Ensemble™ II Transcatheter Valve Delivery System

The Ensemble II Delivery System is the second generation delivery system designed to deliver the Melody™ Transcatheter Pulmonary Valve (TPV). The Ensemble II Delivery system received FDA and CE Mark approval in September 2016.

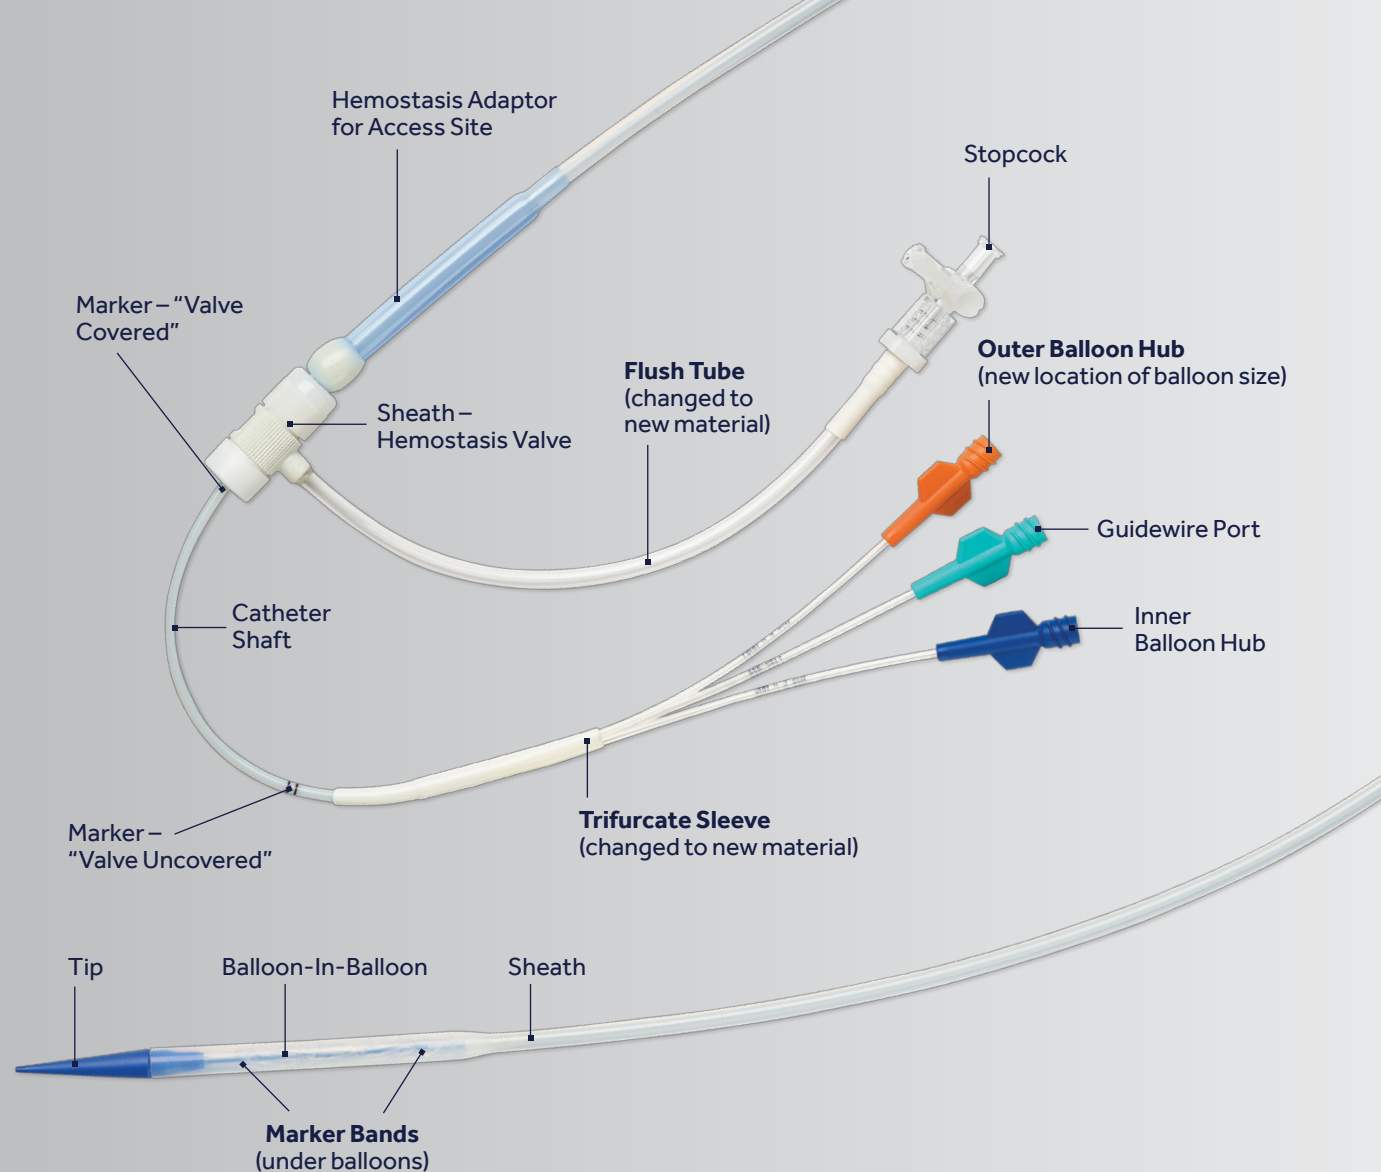
- Addition of marker bands to improve visibility of valve position on the balloons under fluoroscopy prior to unsheathing and during valve deployment.
- The device size marking previously located on the trifurcate sleeve is being relocated to the outer balloon inflation luer hub.
- Trifurcate sleeve and flush tube materials are being changed to phthalate free variants.
- New Product Ordering Numbers (ENS1018, ENS1020, ENS1022)
